FORD:

2014-2015 Fusion

ISSUE

Some 2014-2015 Fusion vehicles built at the Flat Rock assembly plant and built on or before 9/22/2014 may exhibit a condition such as a headliner sag at one or more door openings. The headliner appears to be cut short, does not fit properly or other condition with the headliner for which there is no published repair.

Figure 1 - Article 15-0069

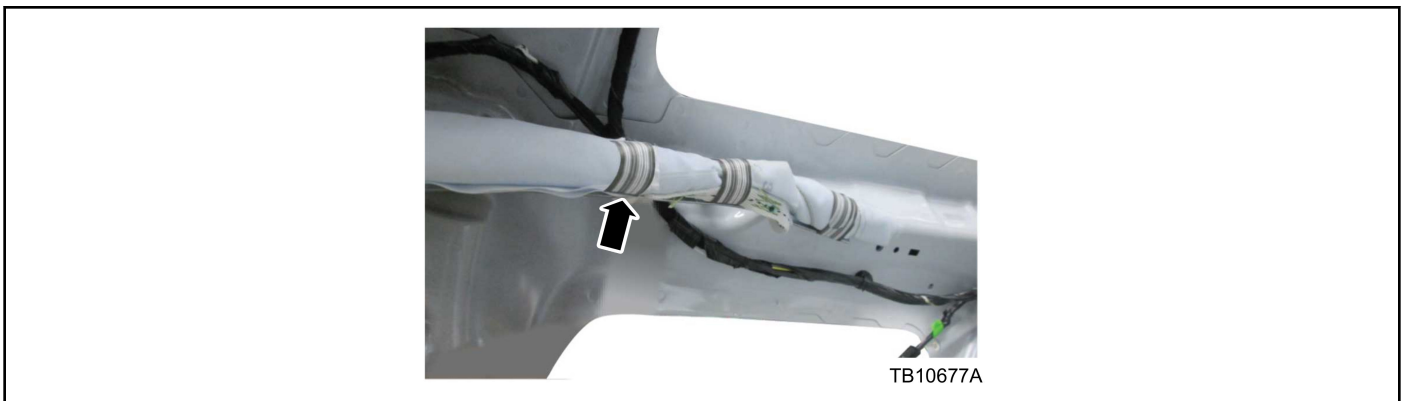
1. Does the first position of the vehicle identification number (VIN) start with a number 1? Refer to Workshop Manual (WSM), Section 100-01.
 - a. Yes - proceed to Step 2.
 - b. No - the vehicle was not built at Flat Rock assembly plant, refer to WSM, Section 501-05 for normal diagnosis.
2. Remove the headliner, refer to WSM, Section 501-05.
3. Without using a cutting tool, hand tear and remove the striped or bar coded piece of tape identified on both the driver and passenger side curtain air bag in the C pillar area. (Figure 1)

- a. When removing the tape it is expected and acceptable for some of the backing or back side of the tape to remain on the curtain air bag. Do not use any chemicals or tools and attempt to remove the backing that remains.
4. Install a new headliner along with updated upper A, B and C pillars which are included in the trim panel kit. Refer to WSM, Section 501-05.
 - a. The original D-pillar trim panel can be reinstalled with a new 2-stage retention clip on each pillar.
5. For 2014 Fusion vehicles install the overhead console attachment kit to the overhead console prior to installing the original overhead console in the new headliner.
